Clinton Power Station, Unit 1
Facility Operating License No. NPF-62
NRC Docket No. 50-461

Subject: Fourth Six-Month Status Report in Response to March 12, 2012 Commission Order Modifying Licenses with Regard to Reliable Spent Fuel Pool Instrumentation (Order Number EA-12-051)

**Fourth Six-Month Status Report for the Implementation of Order EA-12-051, Order
Modifying Licenses with Regard to Reliable Spent Fuel Pool Instrumentation**

Attachment 1 – CPS Schematic of the Level Sensor with Mechanical Attachment Points

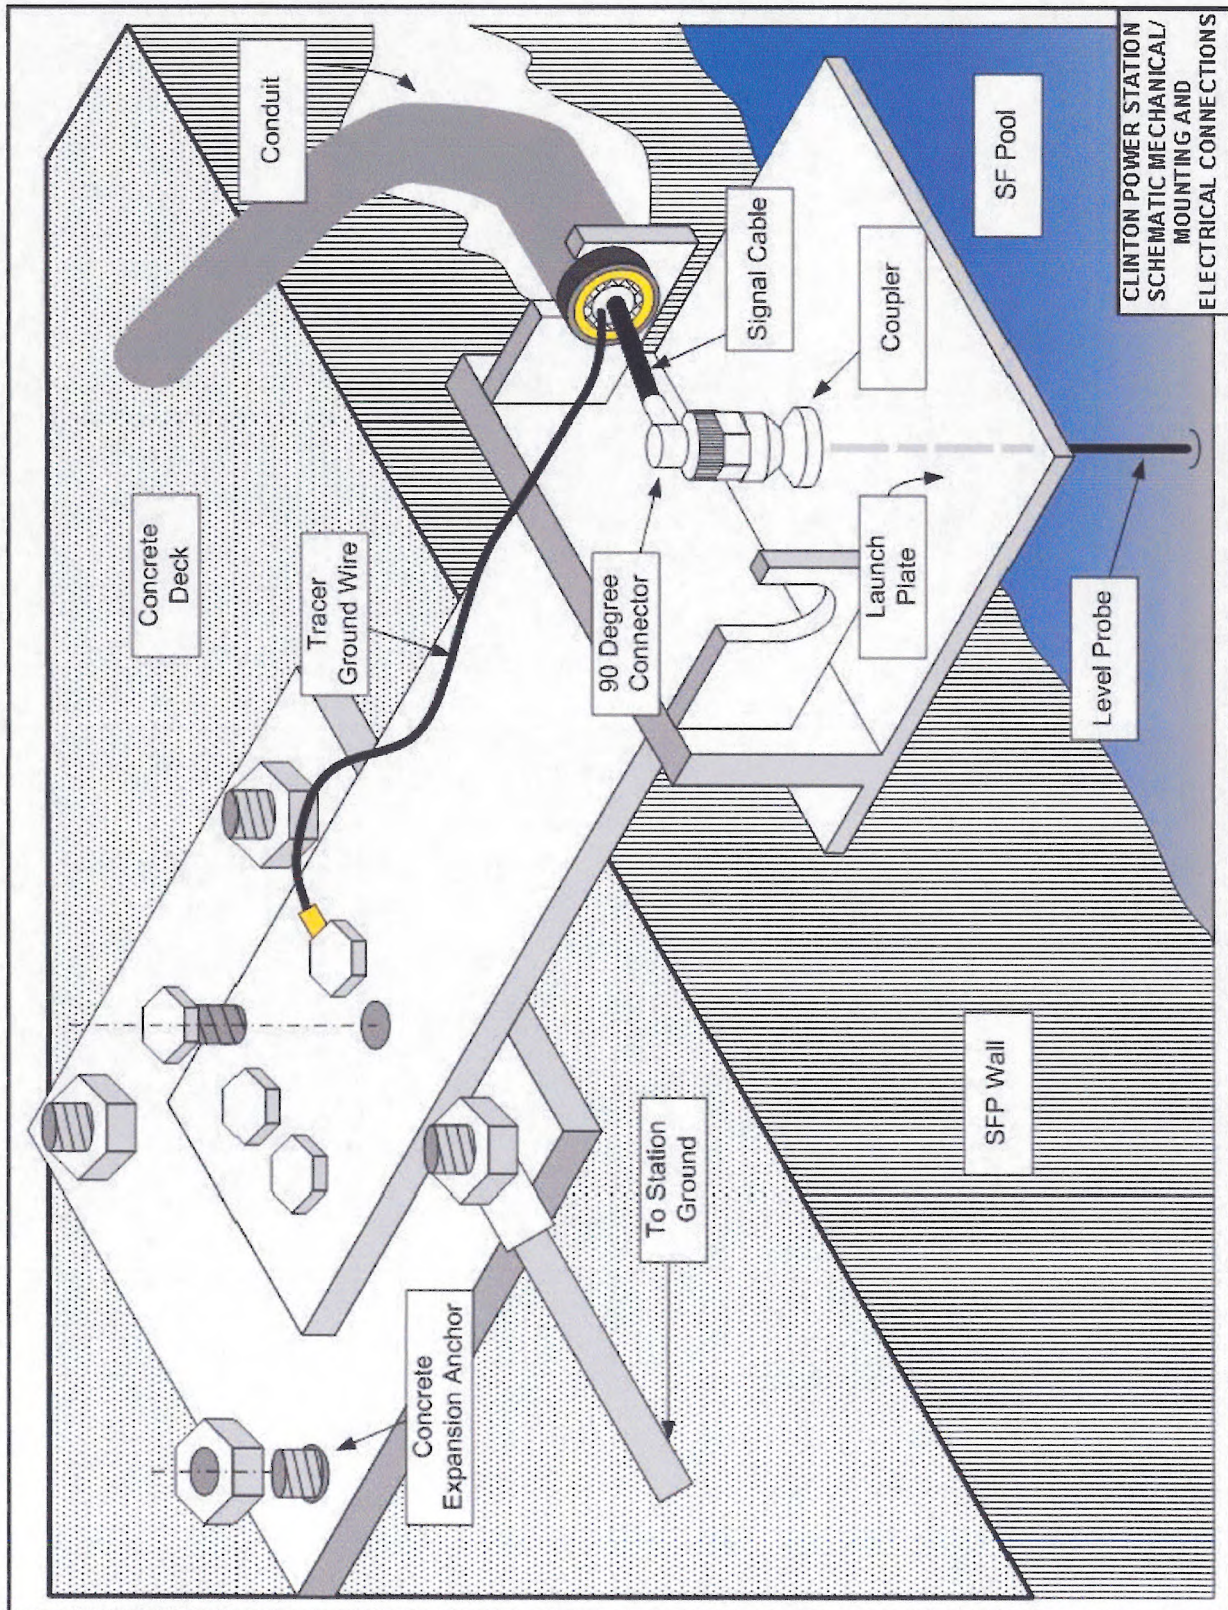
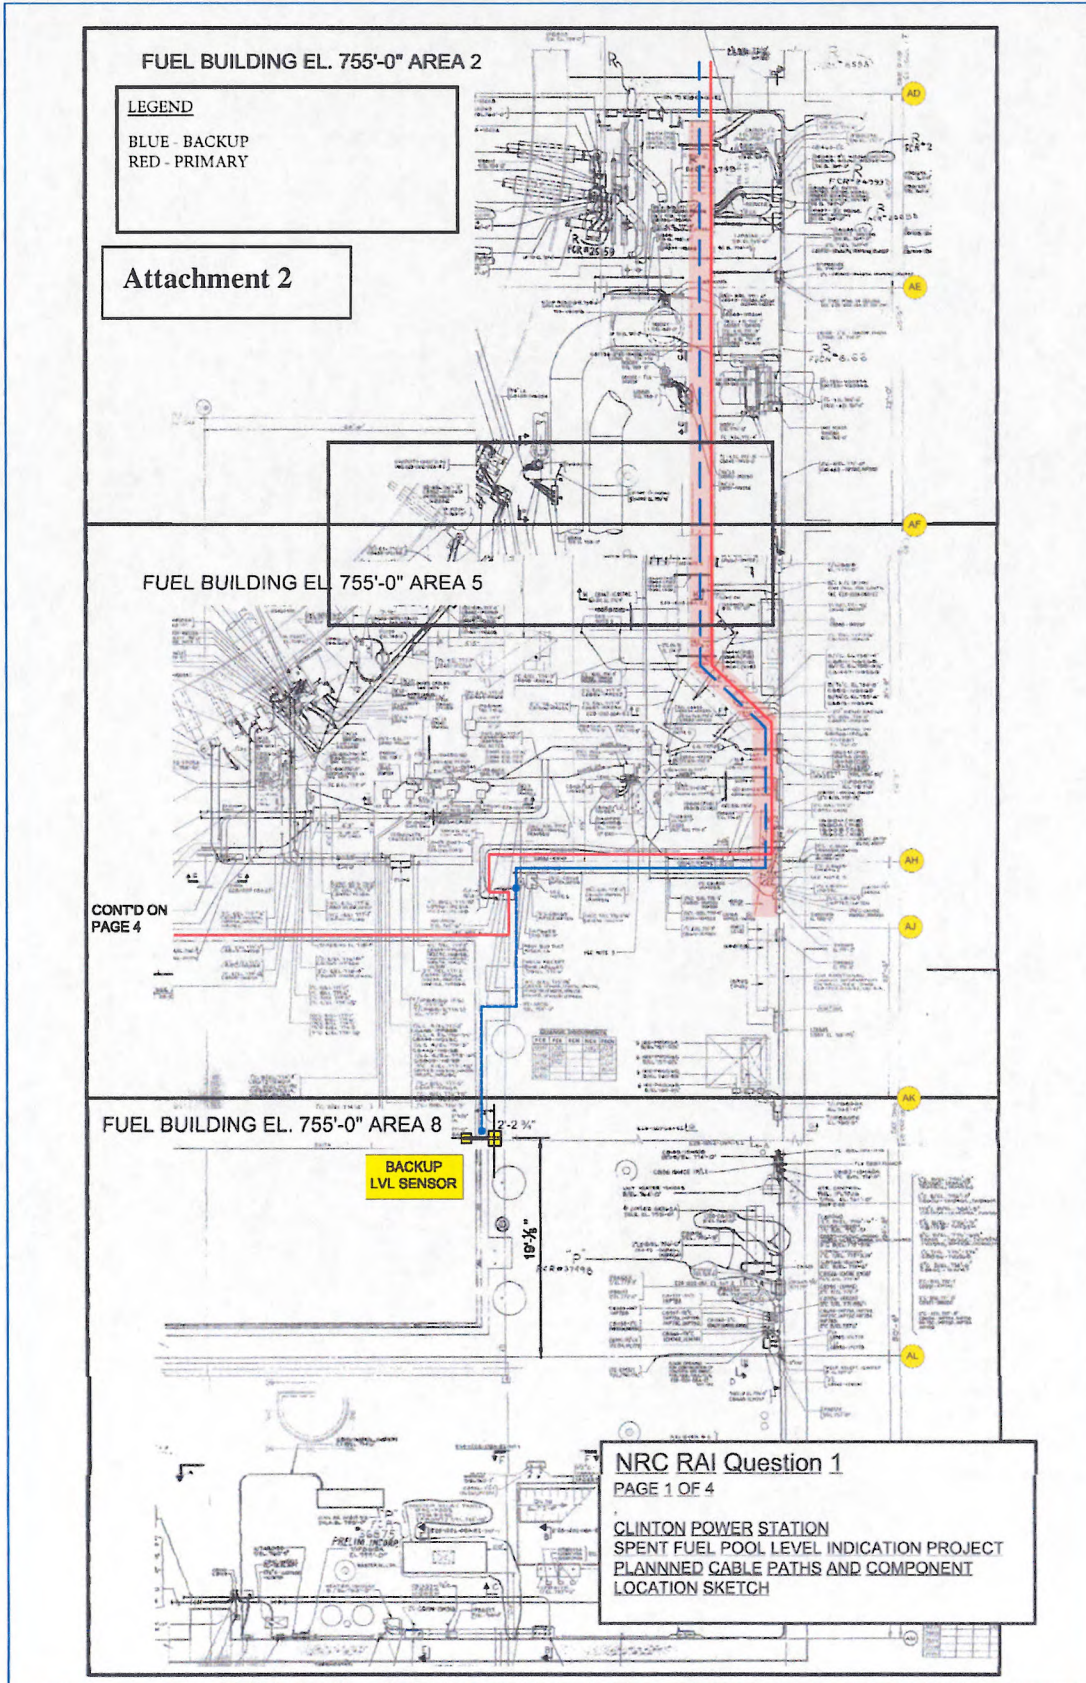
<p>typical mounting arrangement for the portions of instrument channel consisting of permanent measurement channel equipment (e.g., fixed level sensors and/or stilling wells, and mounting brackets). Indicate on this sketch the datum values representing Level 1, Level 2, and Level 3 as well as the top of the fuel racks. Indicate on this sketch the portion of the level sensor measurement range that is sensitive to measurement of the fuel pool level, with respect to the Level 1, Level 2, and Level 3 datum points.</p>	
--	--

<p>connections will attach the level instrument to permanent SFP structures so as to support the level sensor assembly.</p> <p>Part a) – Complete Part b) – Complete Part c) - Complete</p>	<p>determine the potential effects on the sensor.</p> <p>The following Westinghouse documents provide information with respect to the design criteria used, and a description of the methodology used to estimate the total loading on the device.</p> <p>a. CN-PEUS-14-13 –Seismic Analysis of the SFP Mounting bracket at Clinton Power Station</p> <p>b. LTR-SEE-II-13-47, WNA-TR-03149-GEN – Sloshing Analysis</p> <p>c. EQ-QR-269, WNA-TR-03149-GEN, EQ-TP-353 – Seismic Qualification of other components of SFPI</p> <p>Clinton Power Station specific calculations for mounting details associated with Transmitter and SFPLI Monitors have been completed as part of the Engineering Change (EC 392333) package for the modification. The methods used in the calculations followed IEEE Standard 344-2004 and IEEE Standard 323-2003 for seismic qualification of the instrument.</p> <p>b) The level sensor, which is one long probe, is suspended from the launch plate via coupler/connector assembly. The launch plate is a subcomponent of the bracket assembly, which is mounted to the refuel floor via anchors. Attachment 1 shows a schematic of the level sensor with mechanical attachment points. Note that the connection to station ground may deviate from this sketch as the design details are further established in the EC 392333.</p> <p>c) The bracket assembly that supports the sensor probe and launch plate will be mechanically connected to the Fuel Building structure (see Attachment 1). The mechanical connection consists of four concrete expansion anchors that will bolt the bracket assembly to the Fuel Building structure via the base plate. The concrete expansion anchors are designed to withstand an SSE and will meet the CPS seismic related installation requirements. The qualification details of the bracket will be provided in Westinghouse’s Pool-side bracket Seismic Analysis and the qualification of the anchorage to the floor is provided in the supporting CPS specific calculation performed as part of the Engineering Change modification.</p>

NRC RA Question 1
 PAGE 2 OF 4
 CLINTON POWER STATION
 SPENT FUEL POOL LEVEL INDICATION PROJECT
 PLANNED CABLE PATHS AND COMPONENT
 LOCATION SKETCH

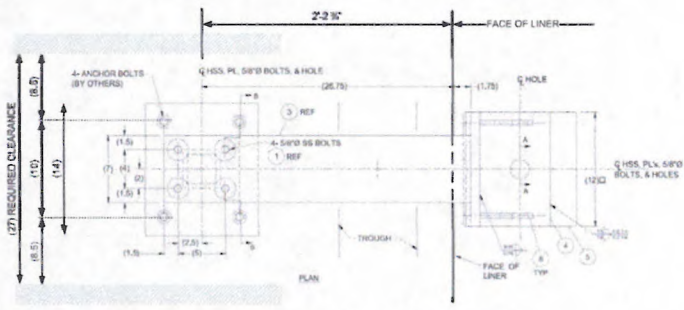
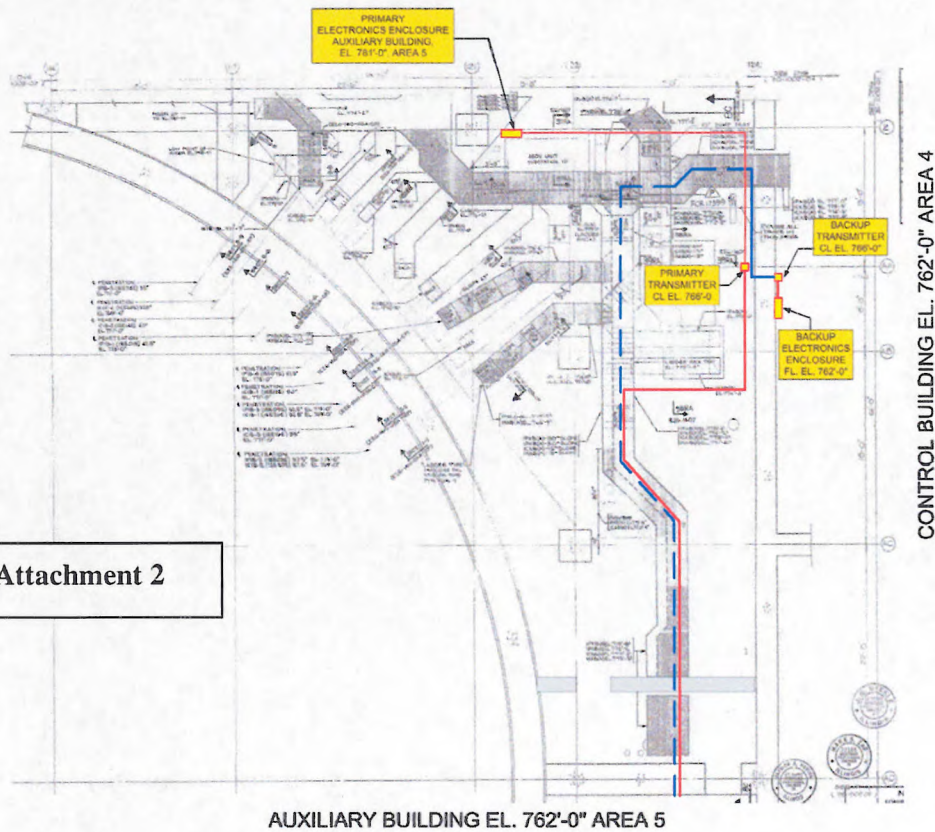
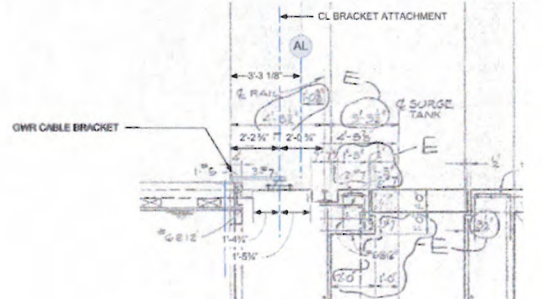
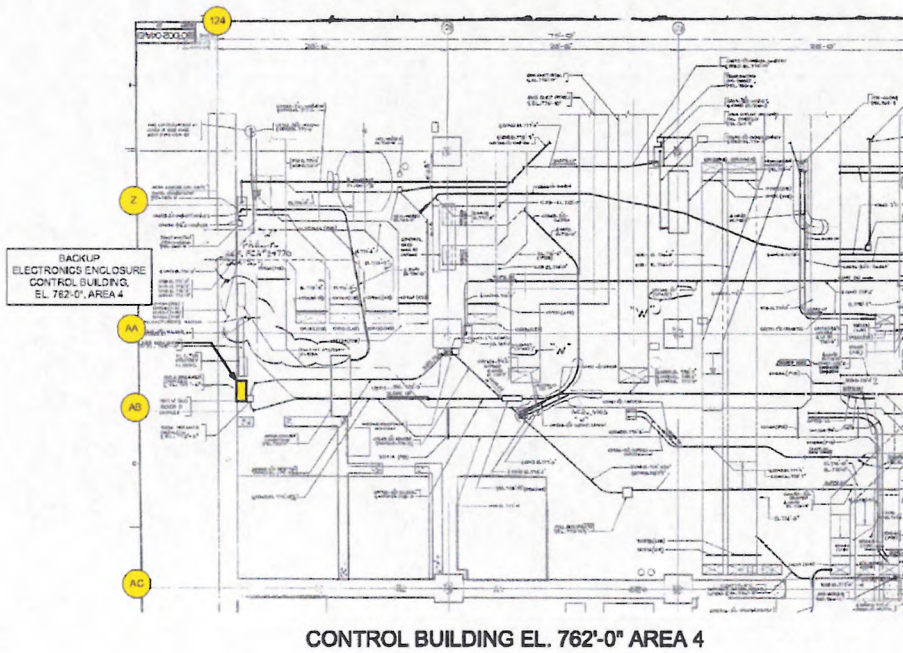
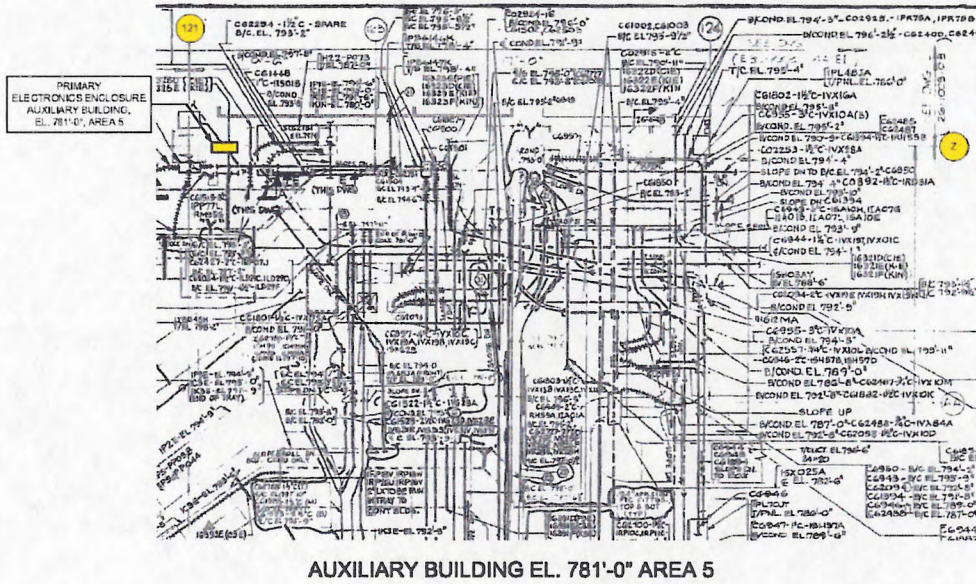
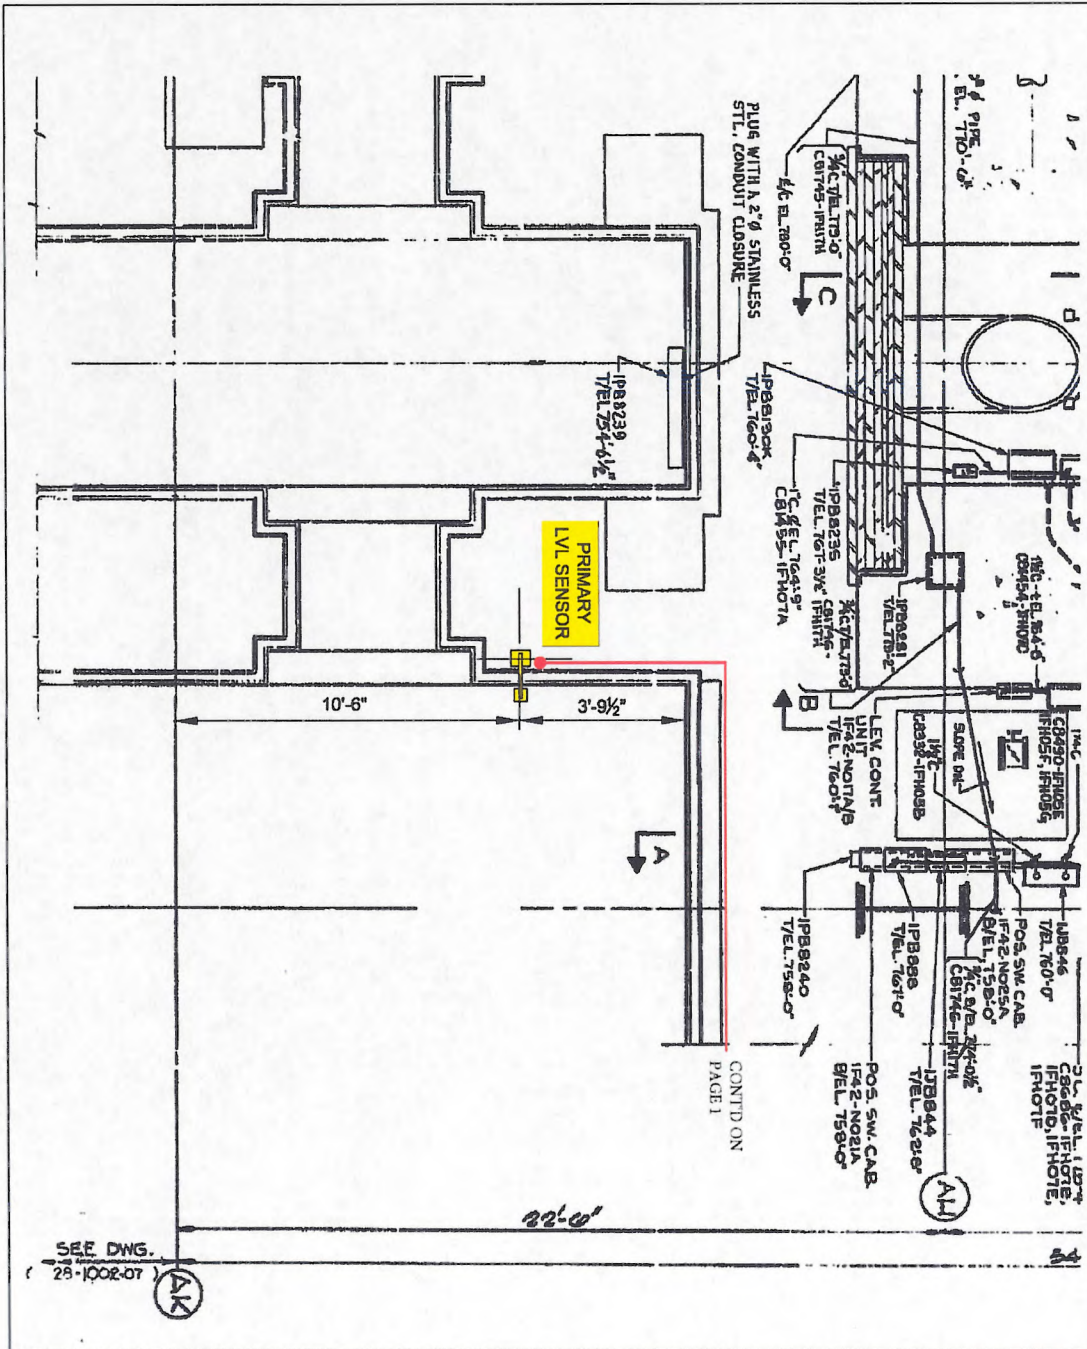
<p>2 (RAI -2, Ref. 3)</p>	<p>RAI Question: Please provide a clearly labeled sketch or marked-up plant drawing of the plan view of the SFP area, depicting the SFP inside dimensions, the planned locations/place ment of the primary and backup SFP level sensor, and the proposed routing of the cables that will extend from the sensors toward the location of the read-out/display device.</p>	<p><u>Complete</u></p> <p>Provided in the attached sketch "NRC RAI Question 1". NOTE: The method of grounding the bracket assembly may deviate from this sketch when further installation/design details are developed.</p>
<p>3 (RAI -3, Ref. 3)</p>	<p>RAI Question: Please provide the following: a) The design criteria that will be used to estimate the total loading on the mounting device(s), including static weight loads and dynamic loads. Describe the methodology</p>	<p><u>Completed with this submittal</u></p> <p>a) All SFPIS equipment will be designed in accordance with the Clinton Power Station (CPS) Safe Shutdown Earthquake (SSE) design requirements.</p> <p>The vendor, Westinghouse, evaluated the structural integrity of the mounting brackets in calculation CN-PEUS-14-13. The GTSTRUDL model was used by Westinghouse to calculate the stresses in the bracket assembly, considers load combinations for the dead load, live load and seismic load on the bracket. The reactionary forces calculated from these loads became the design inputs to design the mounting bracket anchorage to the refuel floor to withstand a Safe Shutdown Earthquake (SSE).</p>
